**Service Bulletin**

**No. : MZ07-039**

**Model:** SR6001

**Subject:** Software Update Information.

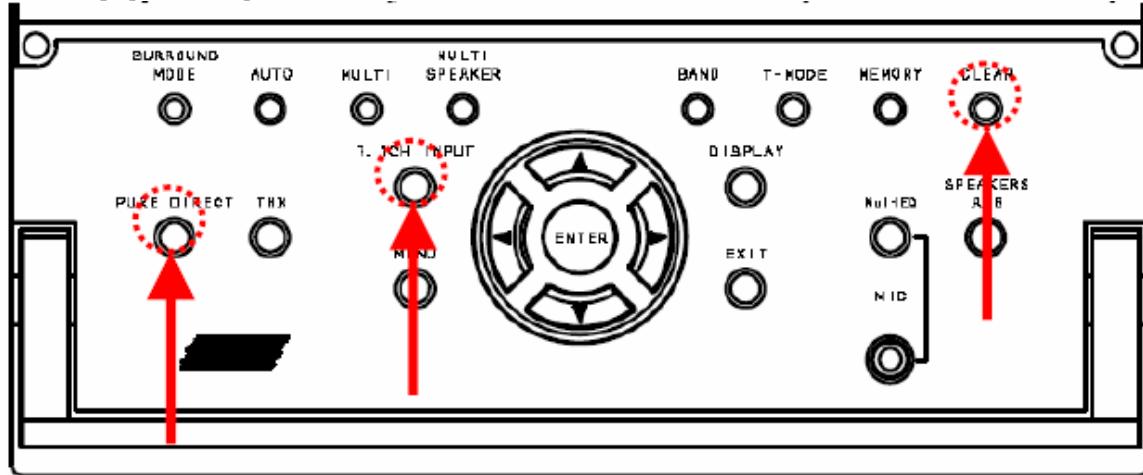
**BEFORE MODIFICATION**

Originally, the unit was designed to go into STANDBY mode with the STANDBY LED flickering every 500m sec. upon detection of an abnormality; it would never be powered on by the standby switch or the remote control, so component over dissipation never occurred. However, if the unit was plugged in again, it could occur before the unit went into standby a few seconds later.

**AFTER MODIFICATION**

The unit has been modified never to be powered on by any means once it goes into standby with the standby led flickering every 125m sec., unless the specialized procedure (\*1) described below is performed.

**\*1: If the unit cannot be powered on after being plugged in again (with the STANDBY LED flickering every 125m seconds), the power amp has failed. The unit still can be powered on again through the following method, but it can further damage the power amplifier. Please never let end-users perform this procedure.**

Can be powered on by “FACTORY KEY” = [PURE DIRECT]+[7.1 CH INPUT]+[CLEAR]
